CHANGE NO. 1

RTCA/DO-210D

Minimum Operational Performance Standards for Geosynchronous Orbit
Aeronautical Mobile Satellite Services (AMSS) Avionics

DO-210D Change No. 1

FIGURE 2-00. RECEIVER SUSCEPTIBILITY

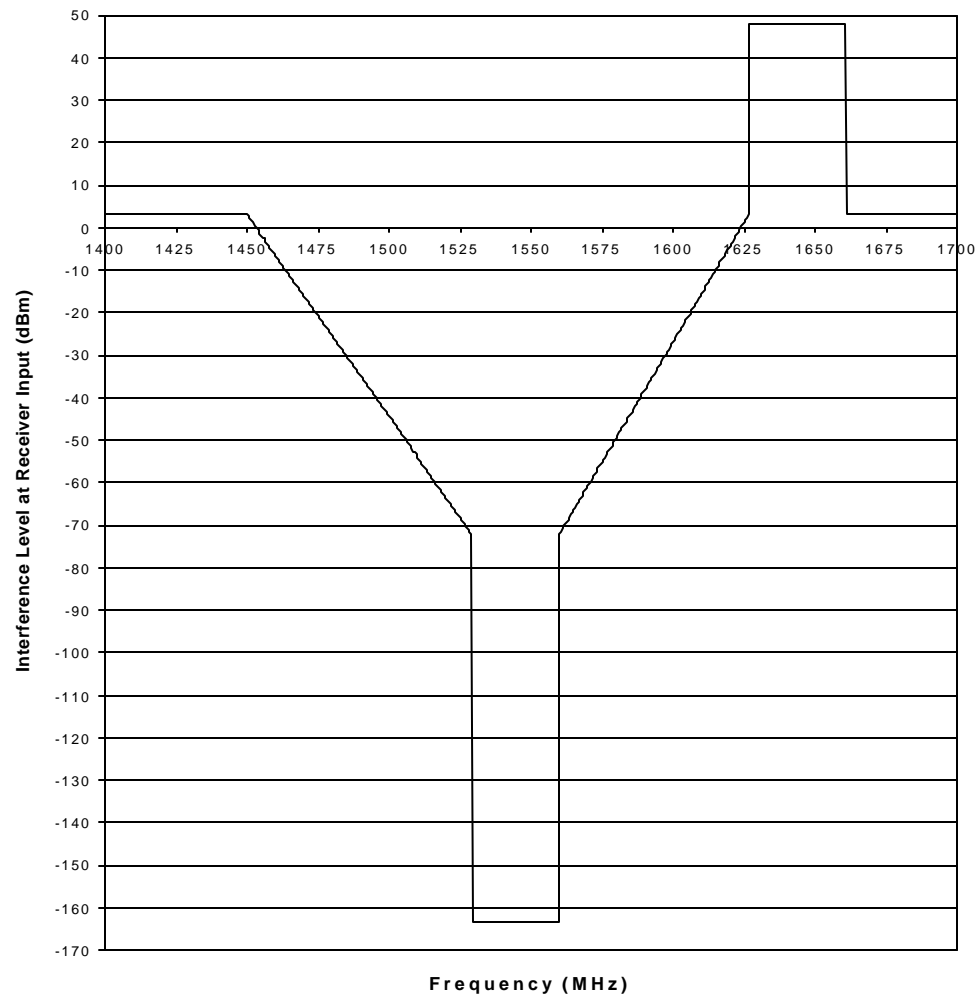
- 1.** Page 5, Section 1.2.3. In the 1st paragraph of text, last sentence, delete the two instances of the word "shall".
- 2.** Page 18. Add a new Section 2.1.9 and Figure 2-00 as follows:

2.1.9 Interference Susceptibility

Receivers meeting the requirements of this document operate satisfactorily in the presence of interference at RF levels at the receiver's input port not exceeding the following tabulated levels. The RF levels in the frequency ranges near the SATCOM receive band are also illustrated in Figure 2-00.

<u>Frequency Range</u>	<u>Maximum Interference Level</u>
470 to 1450 MHz	+3 dBm
1450 to 1529 MHz	Decreases linearly in decibels from +3 dBm at 1450 MHz to -72 dBm at 1529 MHz
1529 to 1560 MHz	-163.2 dBm
1560 to 1626.5 MHz	Increases linearly in decibels from -72 dBm at 1560 MHz to +3 dBm at 1626.5 MHz
1626.5 to 1660.5 MHz	+47.8 dBm
1660.5 to 18000 MHz	+3dBm
